COMMUNITY DEVELOPMENT DEPARTMENT

HEARING DATE: December 8, 2020

SUBJECT: FP-2020-0011
Hensley Station No. 2

Final plat consisting of 26 buildable lots and 3 common lots on 2.01 acres of land in the R-15 zoning district.

A. Preliminary Plat (dated: 10/7/2019)

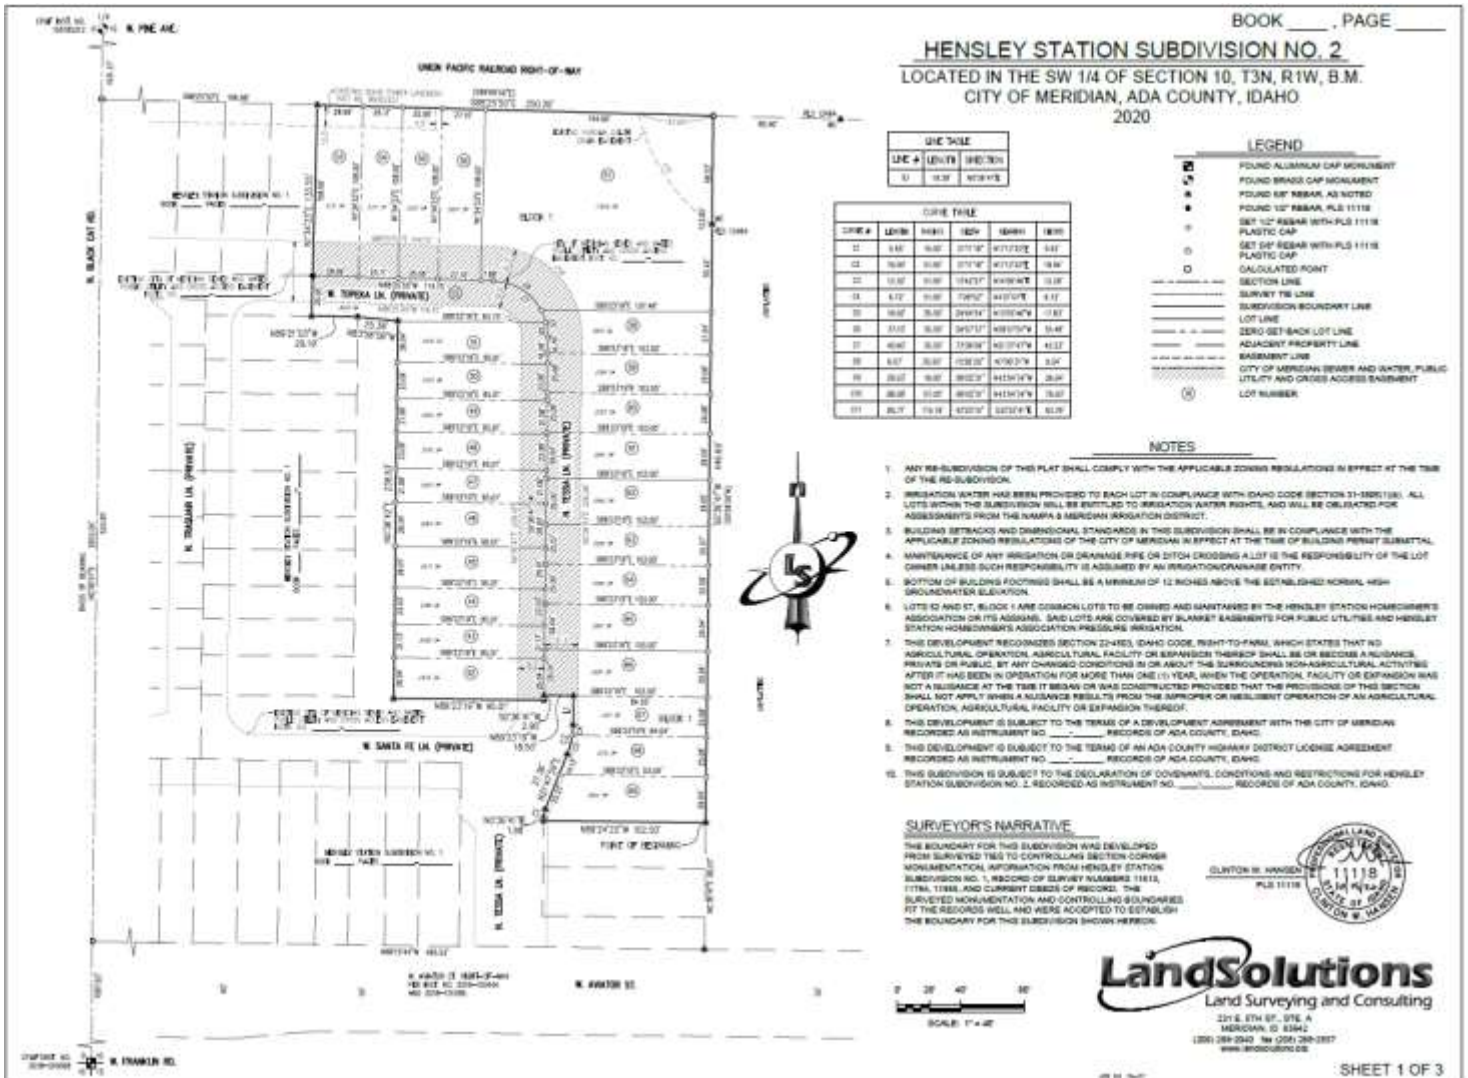
In order for the proposed final plat to be deemed in substantial compliance with the approved preliminary plat as set forth in UDC 11-6B-3C.2, the number of buildable lots cannot increase and the amount of common area cannot decrease. Staff has reviewed the proposed plat and the number

of buildable lots and common open space are the same; therefore, Staff deems the proposed final plat to be in substantial compliance with the approved preliminary plat as required.

B. Final Plat (dated: 10/15/20)

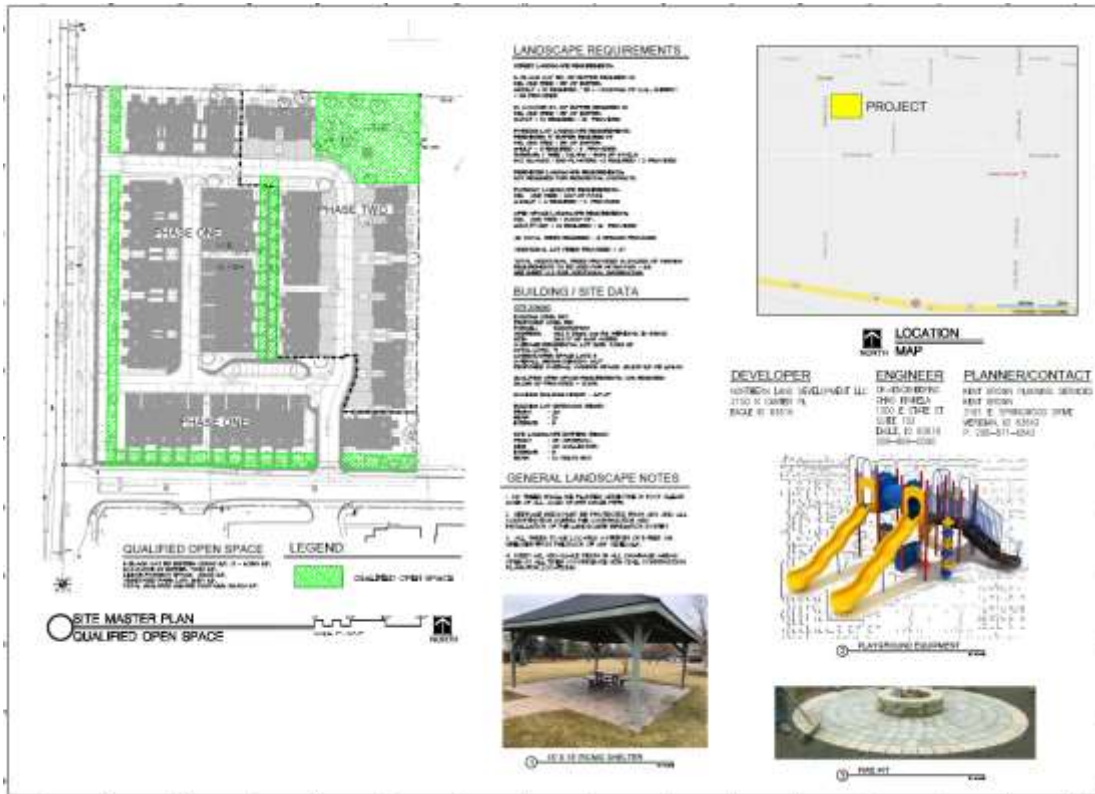
- a. Include the recorded instrument number of the existing City of Meridian water and sewer easement on the face of the plat; remove reference to cross-access easement.

- b. Note #6: "~~Lots 52 and 57, Block 1 are~~ is a common lots to be owned and maintained by the Hensley Station Homeowner's Association or its assigns. Said ~~lots are~~ is covered by blanket easements for public utilities and Hensley Station Homeowner's Association pressure irrigation." *The area shown as Lot 52 is an easement on buildable lots and is not a common lot.*

- c. Note #8: Include the recorded instrument number of the Development Agreement (#2020-029370).
 - d. Note #9: Include the recorded instrument number of the ACHD License Agreement.

- e. Note #10: Include the recorded instrument number of the CC&R's.
 - f. Legend: "City of Meridian sewer and water, public utility and ~~cross-access~~ perpetual ingress-egress easement."

- g. Depict zero (0) lot lines where buildings will span across lot lines.

A copy of the revised plat shall be submitted with the final plat for City Engineer signature.
5. The landscape plan prepared by South, Beck & Baird, dated 04/20/2020, included in Section V.C, is approved as submitted.

C. Landscape Plan (dated: 04/20/2020)

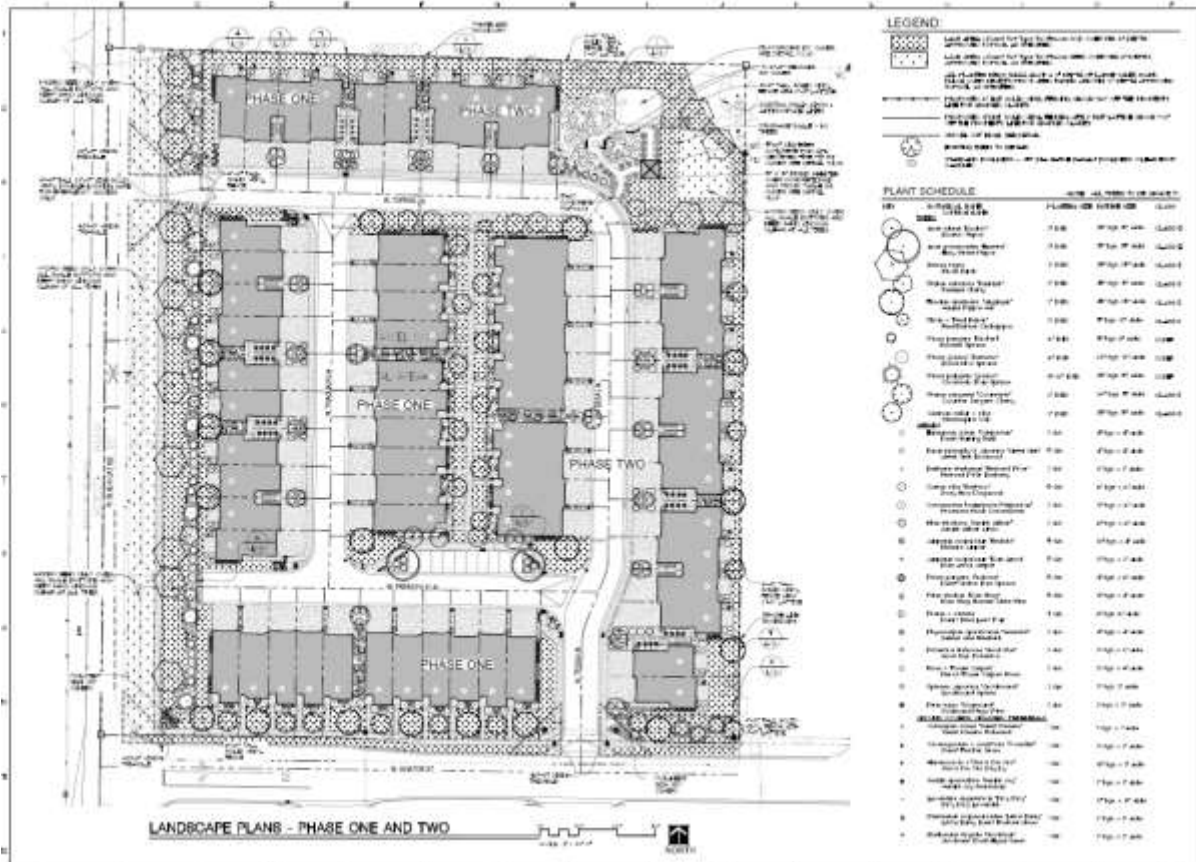
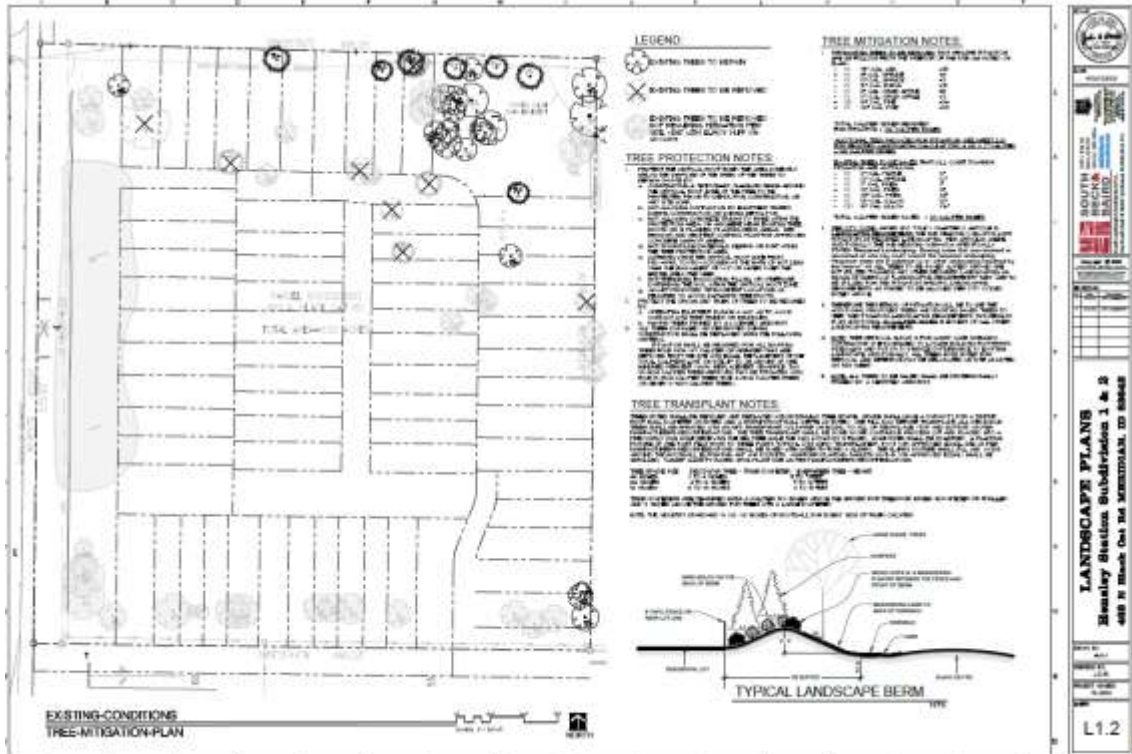
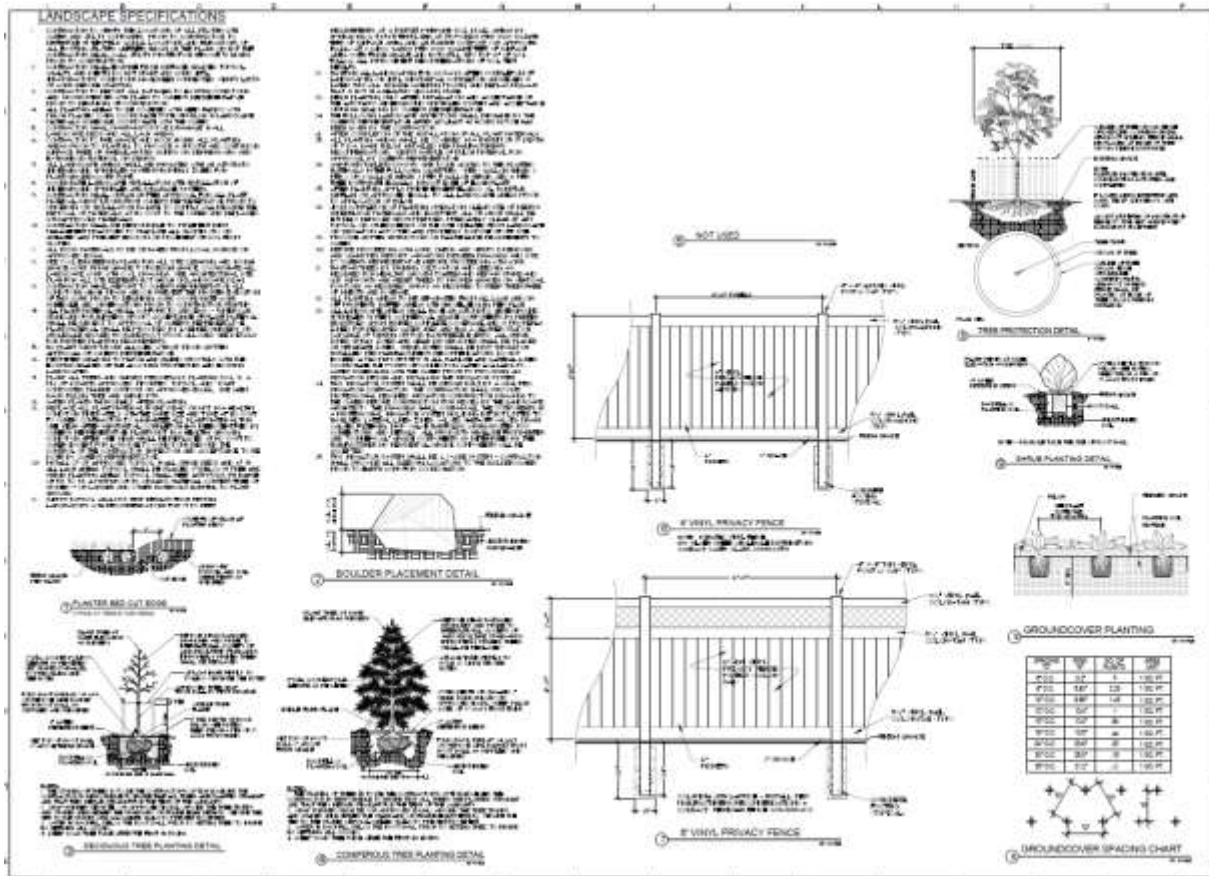
Note: Preliminary plat condition #A.3b required a total of 223 additional caliper inches of trees to be provided on the site for mitigation based on the original inspection by the City Arborist of existing trees on the site anticipated to be removed with development. Since that time, it's been determined that more trees than originally anticipated are able to be retained reducing the calculation to 136 caliper inches required for mitigation – the landscape plan depicts an additional (68) 2-inch caliper trees as mitigation in accord with UDC standards (see letter from Landscape Architect in Section V.C).

This email answers the questions regarding tree preservation and mitigation requirements on the referenced project. The condition of approval on the final plat application spoke to a total of 223 caliper inches being removed. During the course of preparing plans for final plat and construction, we have revised the landscape drawings. Per our current plan set, dated 4-20-2020, we indicate that we reduced the number of existing trees being removed. This new total requires 136 caliper inches to be mitigated for. The landscape drawing L1.0 shows required landscape calculations. These calculations for all required landscape buffers, parking lots, pathways and open space show an extra forty-one (41) 2" caliper trees to be planted. An additional twenty-seven (27) 2" caliper trees will be planted in residential yards above what is required. This totals 68 additional trees being planted on the project in excess of the minimum requirements. The proposed 68 trees equate to 136 caliper inches which equals the 136 caliper inches required to be mitigated.
